**Southern California Edison Company**

Subject: Docket No.1 50-206  
Requests for Additional Information  
San Onofre Nuclear Generating Station  
Unit 1

- References:
1. Letter, George E. Lear, NRC, to Kenneth Baskin, SCE, Request for Additional Information, March 25, 1986
  2. Letter, Richard F. Dudley, NRC, to Kenneth P. Baskin, SCE, San Onofre Unit 1, April 21, 1986.
  3. Letter, Richard F. Dudley, NRC, to Kenneth P. Baskin, SCE, San Onofre Unit 1, April 29, 1986.
  4. Letter, M. O. Medford, SCE, to A. E. Chaffee, NRC, Investigation Report of November 21, 1985 Water Hammer Event, April 8, 1986

- Enclosure 1 - Provides responses to the questions transmitted by Reference 1.
- Enclosure 2 - Provides responses to the questions transmitted by Reference 2.
- Enclosure 3 - Provides responses to the questions transmitted by Reference 3.

CENTER OF GRAVITY SKETCH

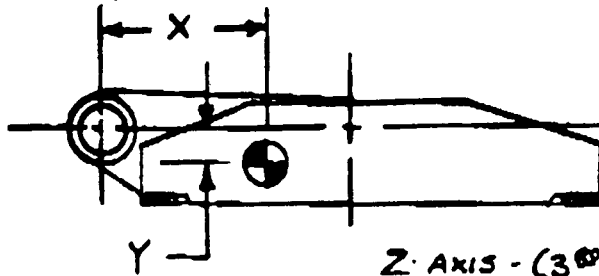
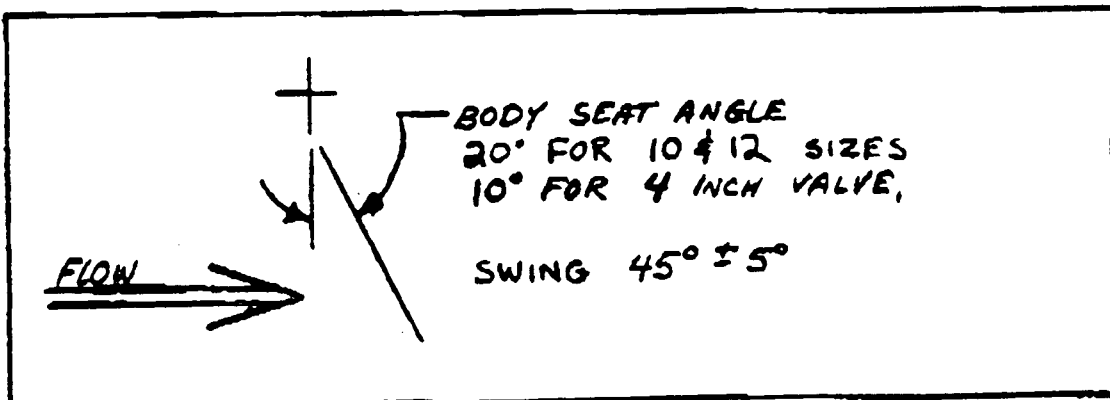
- a. What was the design basis for the 10" and 12" valves in terms of flows, port size, obturator weights, pressure, and temperatures for both the MCC-Pacific and Atwood-Morrill valves? How does this differ from actual values?
- b. What are the acceptable operating ranges for the new valves and what is the impact on plant/system operations?
- c. What are the maintenance, installation, and operation requirements or guidelines provided by MCC-Pacific and Atwood-Morrill?
- d. Will the new valves be modified to include operator assists or position indicators?
- e. What are the "enhanced" surveillance and maintenance requirements and their basis for the Atwood-Morrill valves? Are they from or concurred by the manufacturer?
- f. What are the Atwood-Morrill bonnet and packing torque values?
- g. Where is the Atwood-Morrill actual hinge and disc combination center of gravity?

SIZE	REF.	WGT	X	Y
10	15487-01 15487-05 15487-06 15487-07	51 LBS.	4.65 IN.	.54 IN.
12	15487-02	86 LBS.	6.03 IN.	.64 IN.
4	15487-03	6.2 LBS.	2.17 IN.	.14 IN.

Figure 3. TYPICAL SATISFACTORY ARRANGEMENT OF UPSTREAM AND DOWNSTREAM PIPING.

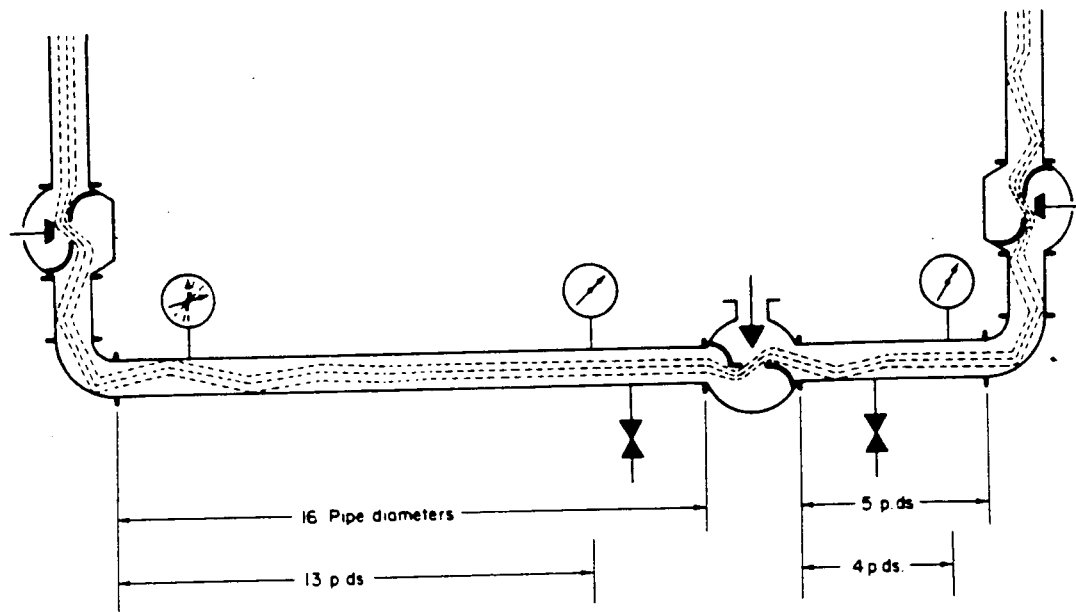
- a. Clarify the method of development of the factor that turbulence loads from upstream components will not exceed 10% of disc weight?
- b. The ISA Handbook of Control Valves provides recommendations on installation. Why or why can't these locational restrictions be correlated to check valves?
- c. Atwood-Morrill recommends not locating check valves within specific distances of turbulence producing components. What is the basis for deviating from these recommendations?

- a. For the response to this question, reference Appendix D of the SCE Investigation Report submitted to the NRC by letter dated April 8, 1986.
- b. The ISA Handbook, Chapter 12, page 339 (Attachment 1), recommends 10-20 pipe diameters of straight run piping upstream of control valves and 3-5 pipe diameters downstream. The handbook acknowledges that the 10-20 diameters upstream may be next to impossible to obtain in line sizes larger than nominal 5". These values actually correlate quite well with those of 10 pipe diameters upstream and 5 diameters downstream given as optimum by Atwood-Morrill for their check valves. However, as explained in our response to Question 3c, Atwood-Morrill check valves can be located at less than these optimum conditions without experiencing any significant vibration or disc flutter.

FIGURE 1

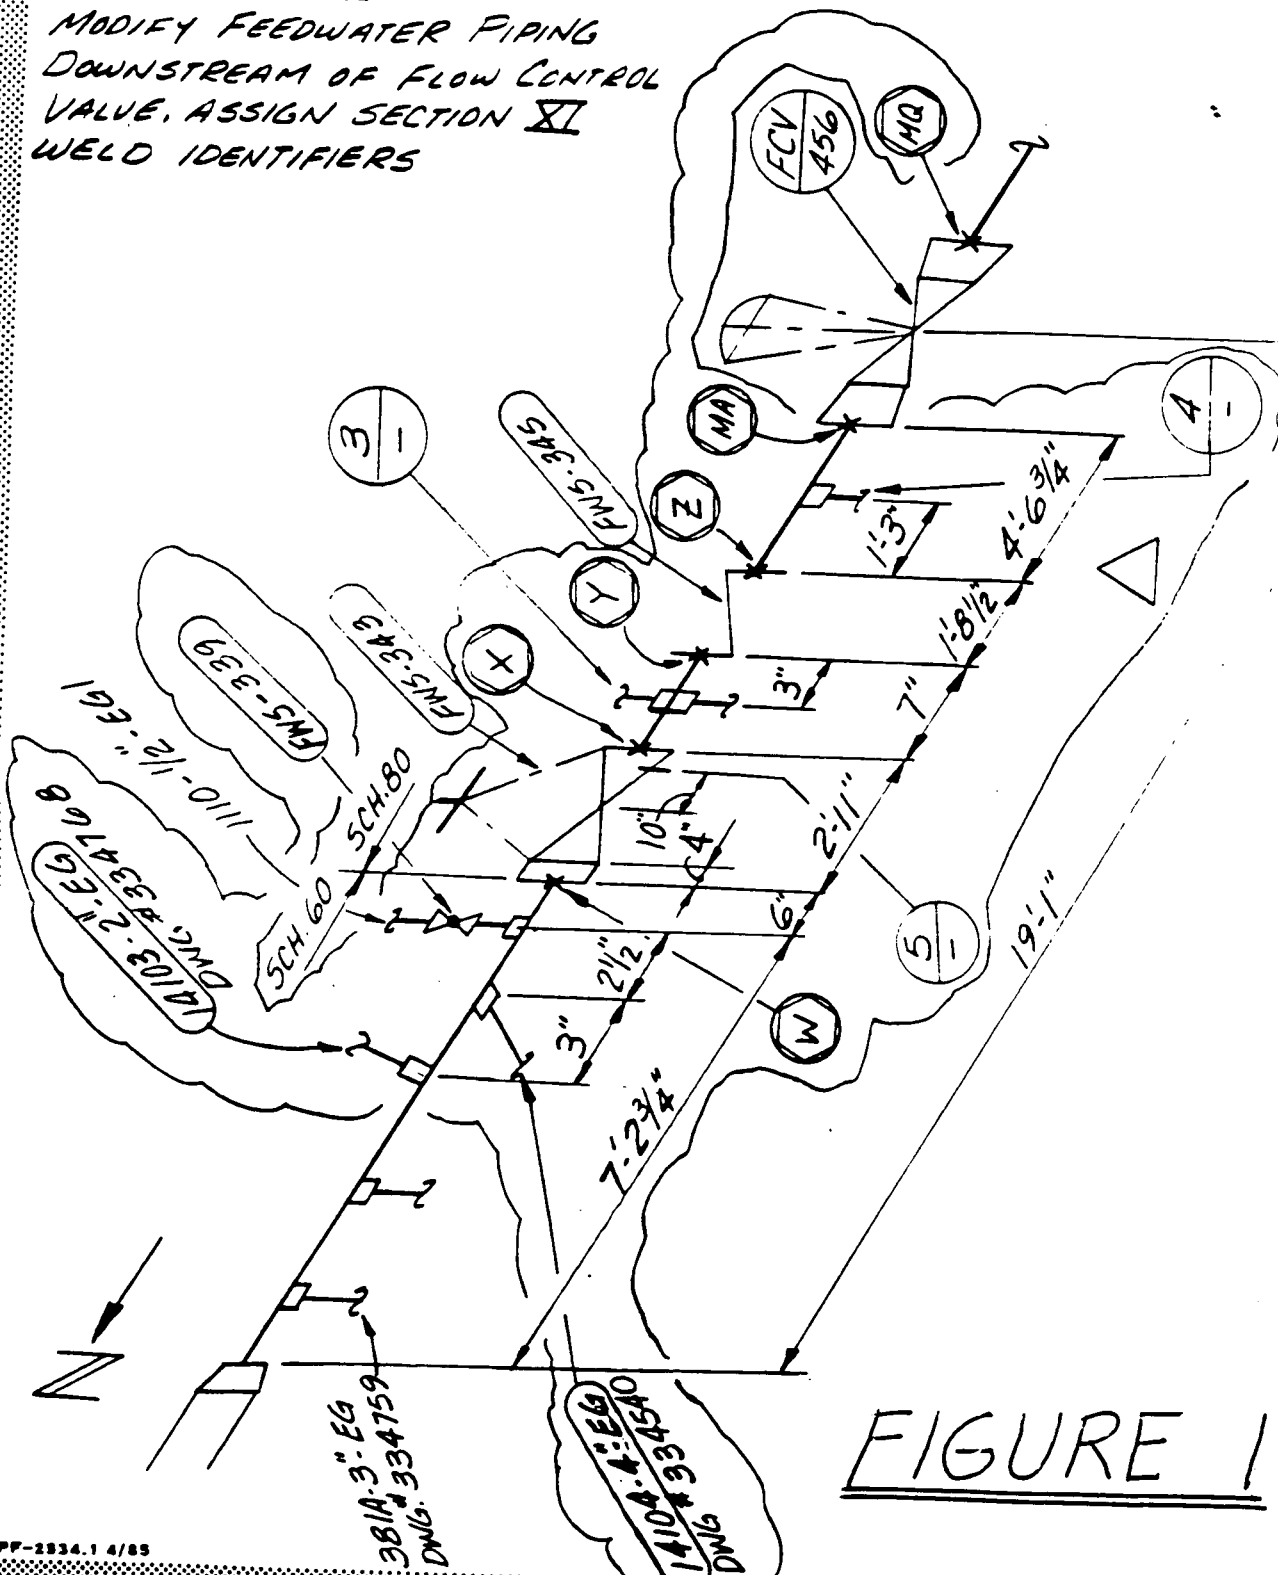
What are the new locations of the 10-inch feedwater system check valves relative to the flow control valve upstream and the block valve downstream? The Isometric Drawings previously provided only show the original locations.

MODIFY FEEDWATER PIPING  
 DOWNSTREAM OF FLOW CONTROL  
 VALVE. ASSIGN SECTION   
 WELD IDENTIFIERS
